SERVICE ADVISORY

NO.: 2185 Rev A

TO: Garmin Integrated Flight Decks and GTN Navigators Owners and Operators
DATE: September 3, 2021
SUBJECT: Abort Approach

Figure 1 – GTN VFOM

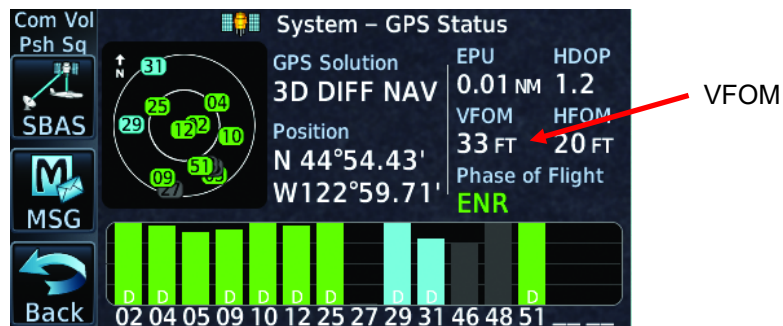
Loading a GPS-based approach before the system has determined a valid GPS position may result in the system aborting the approach.

Before loading a GPS-based approach (indicated as LNAV-only on the selection page) make sure the VFOM (Vertical Figure of Merit) value on the GPS Status page is less than 106 feet.

This will be fixed in a future software release.
